TECHNICAL NOTE

Homes by Honey

**Penistone Road,
Fenay Bridge, Huddersfield, HD8 0JS**

REF NUMBER: 102384-4

Figure 1 Proposed Extensions at Rowley Mills

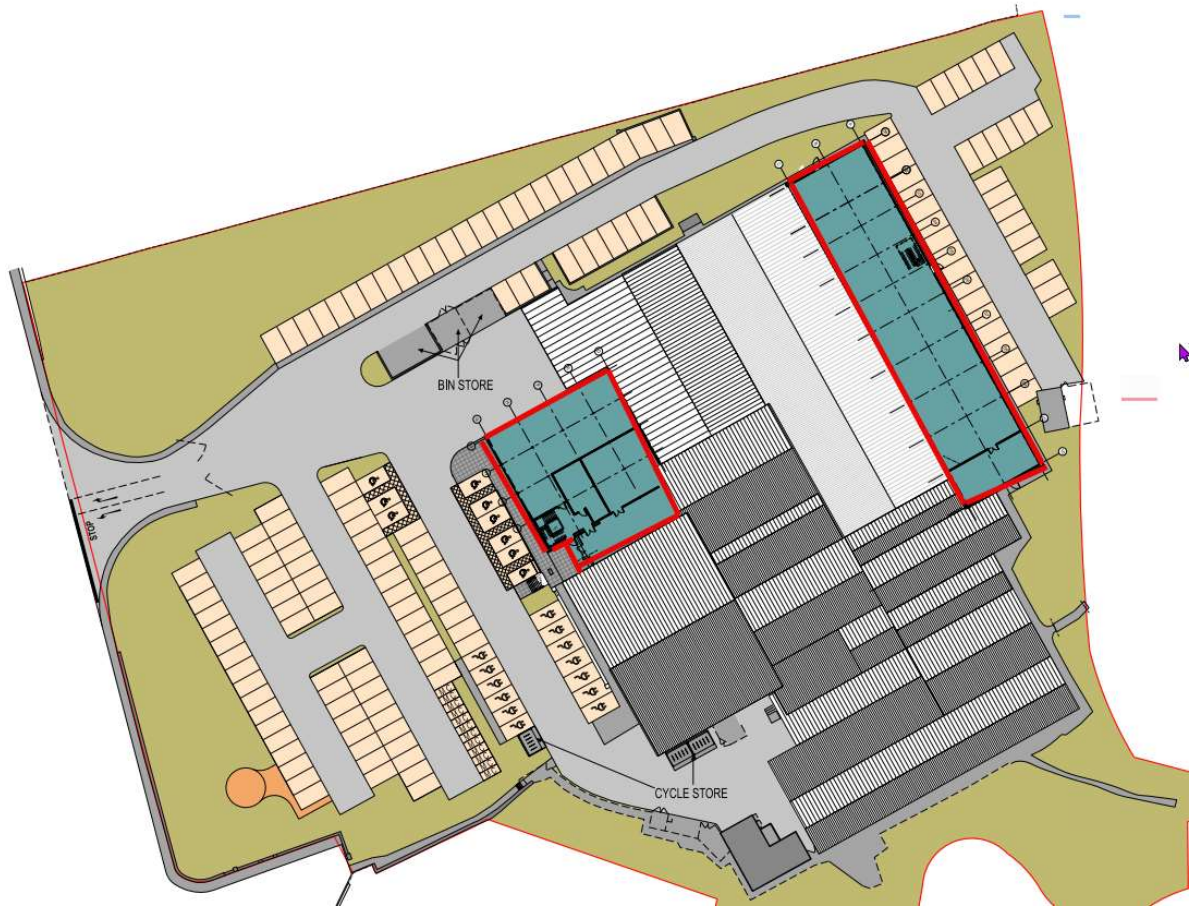
- extending the main manufacturing workshop area at the rear of the building with a new 2-storey extension providing manufacturing space at ground floor level and office space at 1st floor level. The extension of the workshop building will move this noise source closer to the boundary and existing receptors to the north east.
- A new 3-storey extension to the front (west) of the site to provide office, conference, and canteen spaces.

3.2 The location of the two extensions is shown outlined in red in Figure 1 below.

Figure 2 Snip from the 3D Model View within the BTA Report

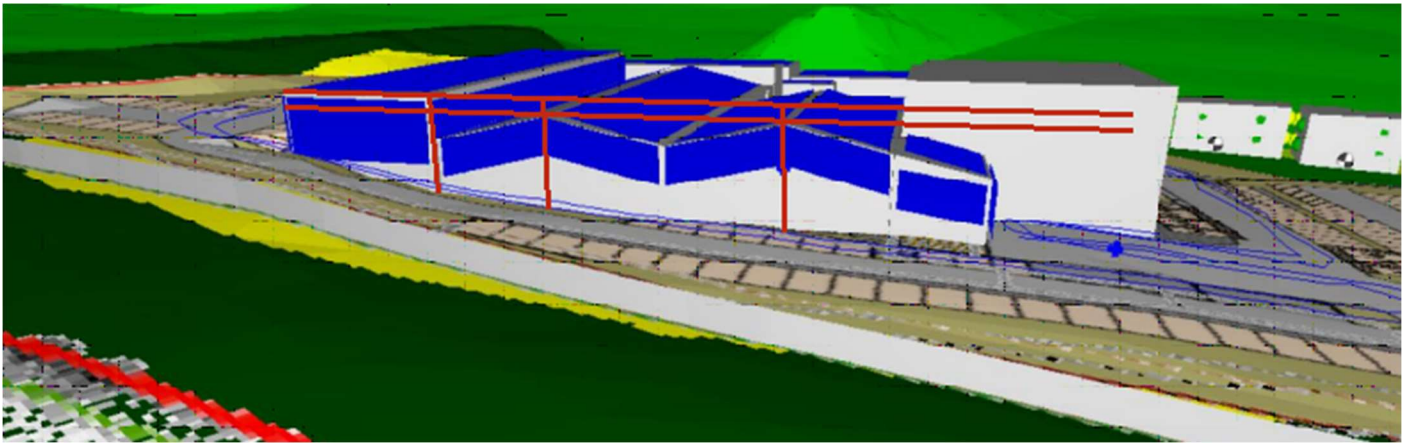
- 3.3 The graphic on page 47 (of the BTA report) indicates that the entirety of the new workshop building to the east of Rowley Mills is being modelled as radiating area sources, including the roof. Noise through the roof is likely to be negligible after passing through the first-floor office space. Additionally, walls at first-floor level are likely to have very different noise emissions than the ground-floor owing to the different uses of the spaces.
- 3.4 The same graphic appears to indicate that the eastern extension will be higher than the existing workshop building, contrary to the statement in para 4.8 that *"The existing banking to the carpark will be dug out and retaining works will be undertaken to provide space for the new extension, which will be built to the same height as the existing building"*. A snip of the graphic is provided in Figure 2.
